Re: Proposed Milford Township Draft Wellhead Protection Ordinance – Written Comments by the Delaware Riverkeeper Network before the July 7, 2021 Township Meeting

From: Criswell, Alexander B. [criswellab@cdmsmith.com]
Sent: Wednesday, July 07, 2021 3:54 PM
To: Milford Township; wateropr@gmail.com
Cc: King, Abraham J.; Remphrey, Byrne
Subject: RE: CDM Smith Notification Discussion at the Supervisors' Meeting
Attachments: 2021WSIPlans_MilfordTownship.pdf

MUNICIPAL AUTHORITY OF THE BOROUGH OF MILFORD
PIKE COUNTY, PENNSYLVANIA

WATER SYSTEM IMPROVEMENTS

PLAN AND PROFILE
 STA 12+00 TO STA 18+11

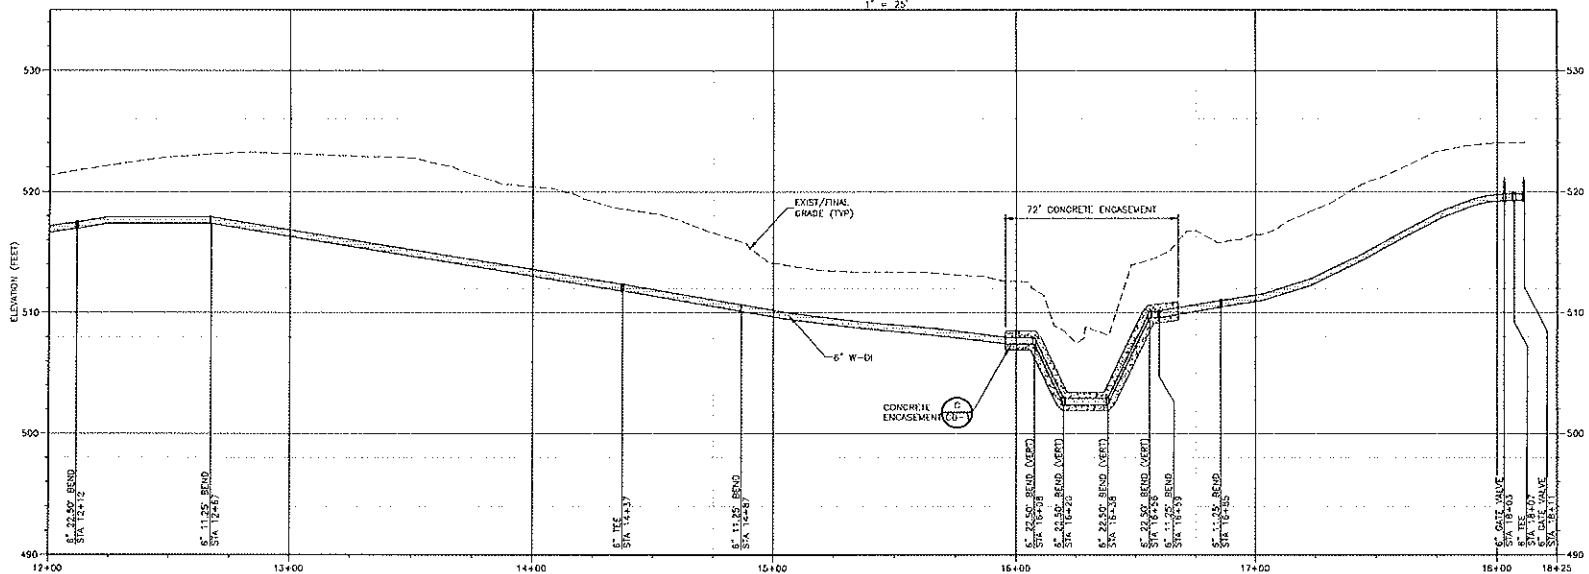
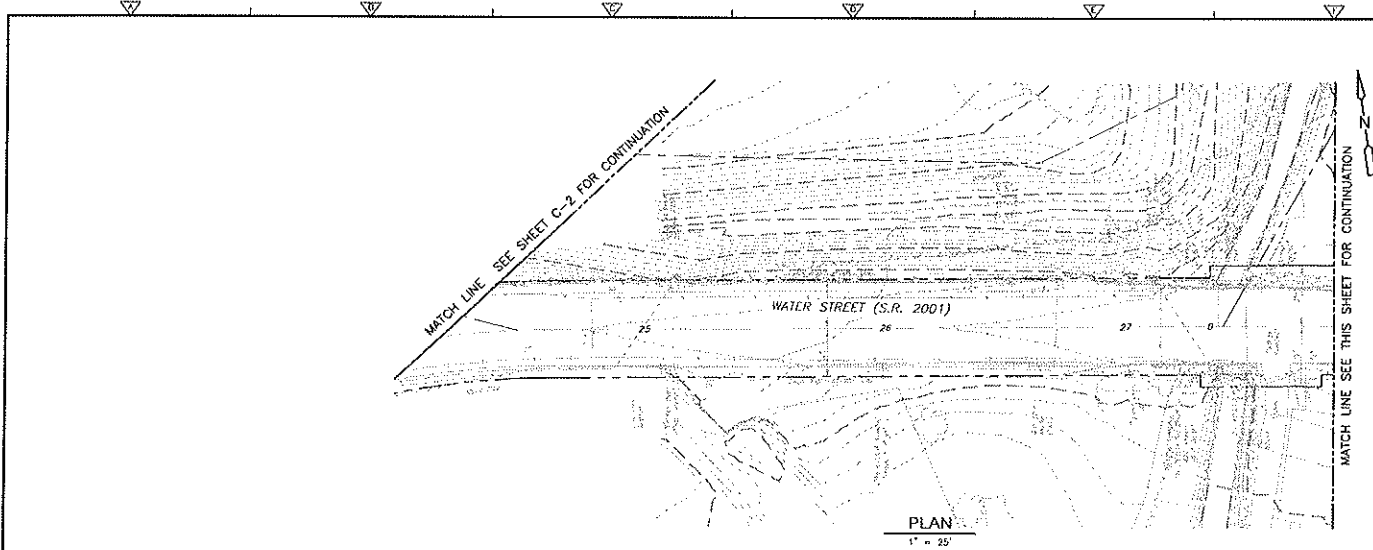
1. What is the exact location of the above ground pump?
2. Is it going to generate any noise or exhaust fumes?
3. What's the distance from the nearest building that is not on sight?
4. In terms of emergency management planning, is there any information about what the potential for flood risk is if one of those towers comes down.
5. Will another stream crossing be added?
6. Check with the Zoning Officer and the Building Officer for what permits would be required.

5. We are planning two stream crossings in our plans, both crossing Vantine creek. Please refer to pages C-3 and C-5 for the location of these crossings. In both cases the pipe will be buried under the stream and encased in concrete. We also plan to install a culvert over the crossing near the treatment plant to facilitate an access driveway for maintenance. In both cases, we show details on sheets CD-3 and CD-3A for how these crossings will be installed. The stream crossing detail on sheet CD-3A also includes erosion and sediment control details specific to these installations as well.
